**STAFF REPORT**  
(One-Step Final Plat)

**CASE NUMBER:** S/D 00-18 -- ROONEYS' FIRST ADDITION

**SURVEYOR/ENGINEER:** Terra Tech Land Surveying, Inc., 239 N. Ohio, Wichita, KS 67214

"Rooneys' First Addition" Closure Computations

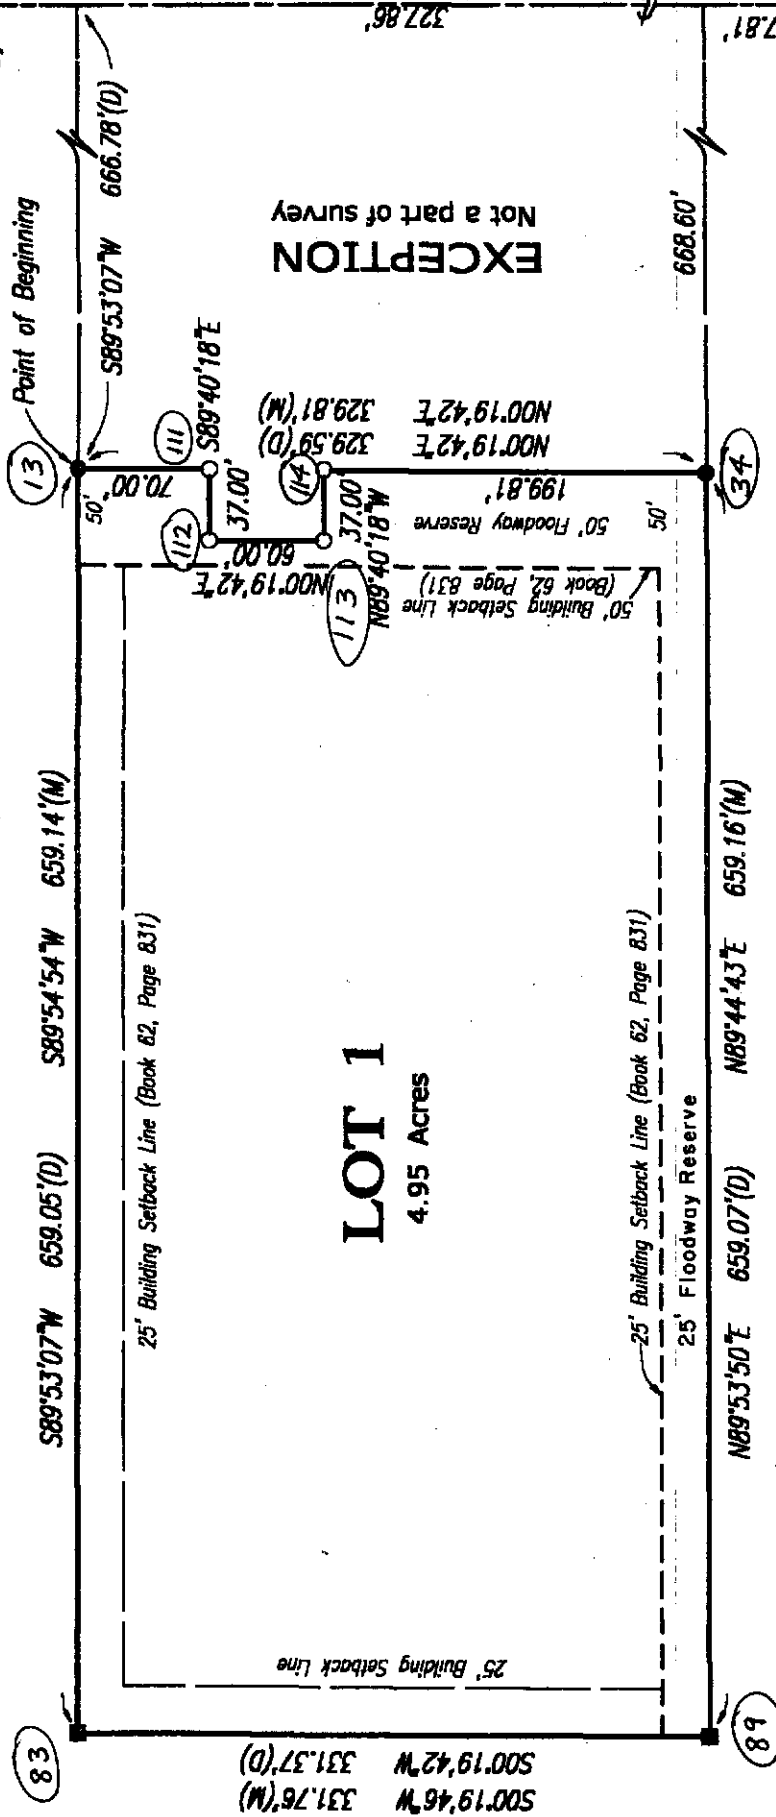
- C. County Engineering needs to comment on the status of the applicant's drainage plan. *A Floodway Reserve is required along the south lot line and on the east lot line.*

- D. County Engineering and County Fire Department needs to comment on the access to this property. The plat proposes access through an existing 50-ft private street which currently serves three lots. The Subdivision regulations limit private streets to serving no more than three lots. Approval of the proposed plat would require a modification from the Subdivision regulations. An ingress/egress easement needs to be established by separate instrument which includes this lot.

- E. The plattor's text shall note the creation of the floodway reserve in addition to referencing the standard floodway language.
- F. For those reserves being platted for floodway purposes, the required covenant which provides for ownership and maintenance of the reserves shall grant, to the appropriate governing body, the authority to maintain the reserves in the event the owner fails to do so. The covenant shall provide for the cost of such maintenance to be charged back to the owner by the governing body.
